# HISTORIC AND DESIGN REVIEW COMMISSION

October 16, 2024

**HDRC CASE NO:** 2024-341  
**ADDRESS:** 634 CEDAR ST  
**LEGAL DESCRIPTION:** NCB 2912 BLK 1 LOT S 10 FT OF 8 & N 40 FT OF 9  
**ZONING:** RM-4, H  
**CITY COUNCIL DIST.:** 1  
**DISTRICT:** King William Historic District  
**APPLICANT:** Victoria Gough/Lush GreenScape Design  
**OWNER:** Alejandro Garcia/GARCIA ALEJANDRO A  
**TYPE OF WORK:** Demolition of rear accessory structure, carport installation, front fence installation, site modifications  
**APPLICATION RECEIVED:** September 04, 2024  
**60-DAY REVIEW:** November 03, 2024  
**CASE MANAGER:** Rachel Rettaliata

**Demo Plan**

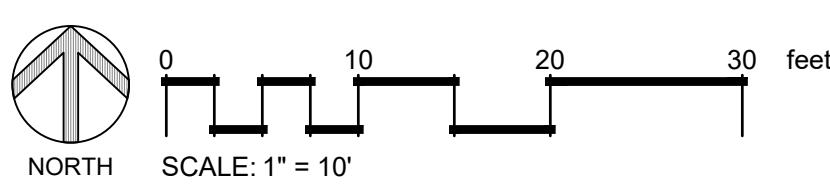
- b. DEMOLITION OF REAR ACCESSORY STRUCTURE – The applicant is requesting approval for the demolition of the rear accessory structure only. In general, accessory structures contribute to the character of historic properties and the historical development pattern within a historic district.

- e. LOSS OF SIGNIFICANCE – In accordance with UDC Section 35-614(c), demolition may be recommended if the owner has provided sufficient evidence to support a finding that the structure has undergone significant and irreversible changes which have caused it to lose historic, cultural, architectural, or archaeological significance, qualities or features which qualified the structure or property for such designation. The 1-story rear accessory structure features a metal hip, exposed rafter tails, and board-and-batten cladding. The structure shows obvious evidence of deterioration, including wood rot but staff finds that the structure is repairable.

Item 1, staff does not recommend approval of the demolition of the rear accessory structure based on findings a through d. If the HDRC is compelled to approve the demolition of the rear accessory structure, the City's Deconstruction Ordinance shall apply.

5 WOOD PICKET FENCE  
1" = 1'-0"

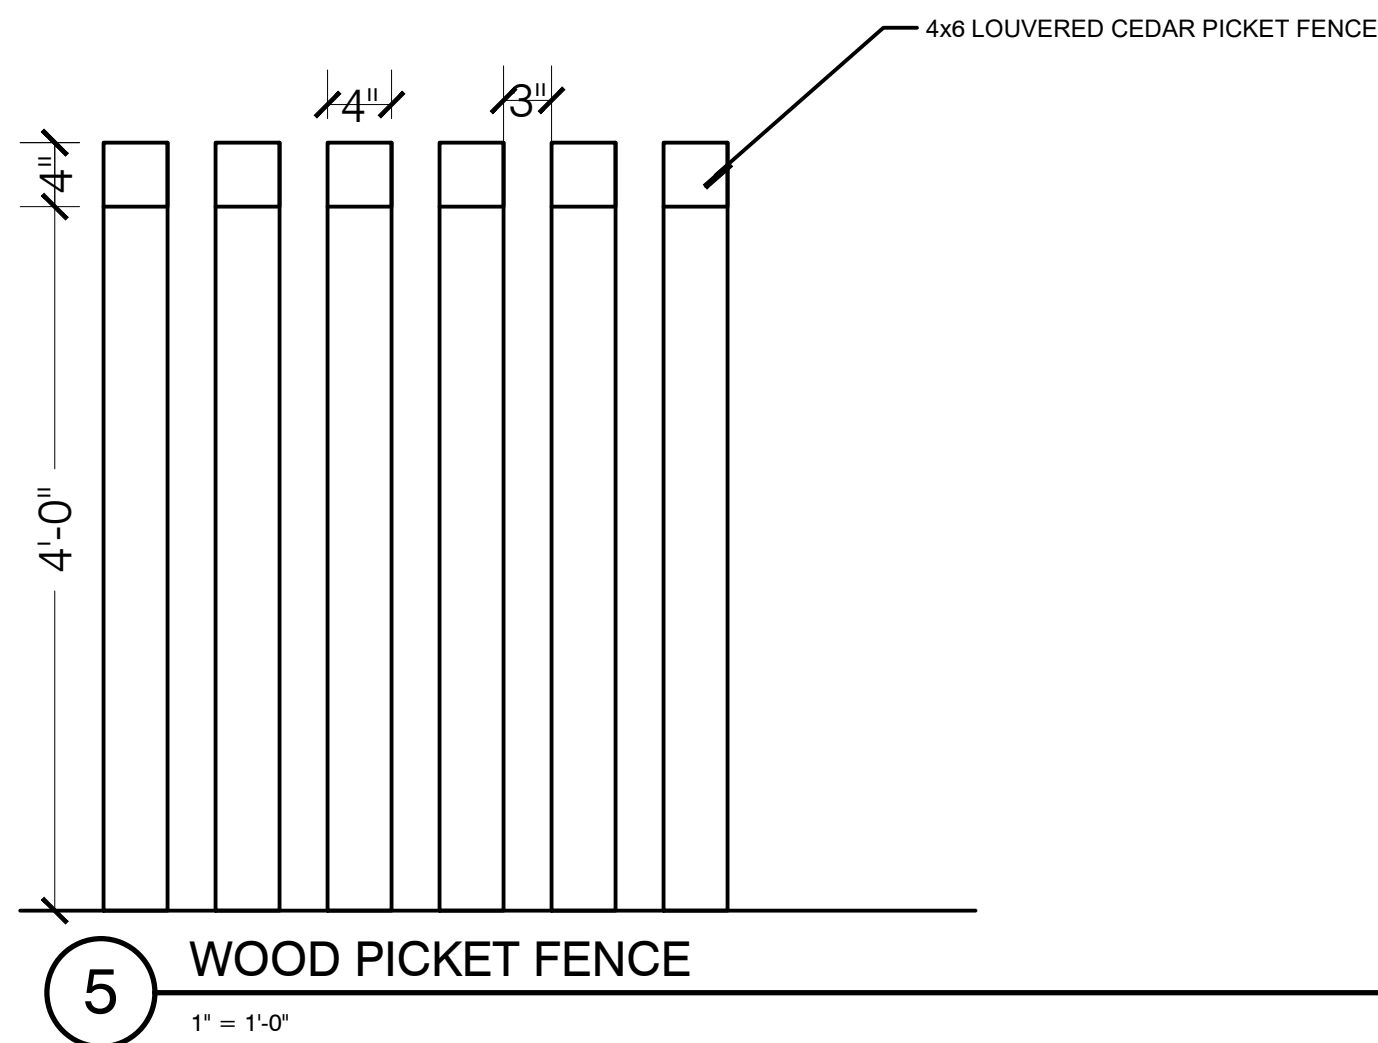
- h. FRONT YARD FENCE INSTALLATION – The applicant has proposed to install a 4-foot-tall, louvered wood picket front yard fence. The design of the louvered pickets is contemporary in style and will feature a pedestrian gate at the front walkway and will turn in at the driveway. Guideline 2.B.i. for Site Elements states that new fences and walls should appear similar to those used historically within the district in terms of their scale, transparency, and character. Design of fence should respond to the design and materials of the house or main structure. Staff finds that although the design is contemporary, open wood picket fences are traditionally found in the King William Historic District. Staff finds the proposal appropriate.

Item 4, staff recommends approval of the front yard fence installation based on finding g with the following stipulation:

- i. That the final construction height of the approved fencing may not exceed the maximum height of 4 feet as approved by the HDRC at any portion of the fence. Additionally, the fencing must be permitted and meet the development standards outlined in UDC Section 35-514.
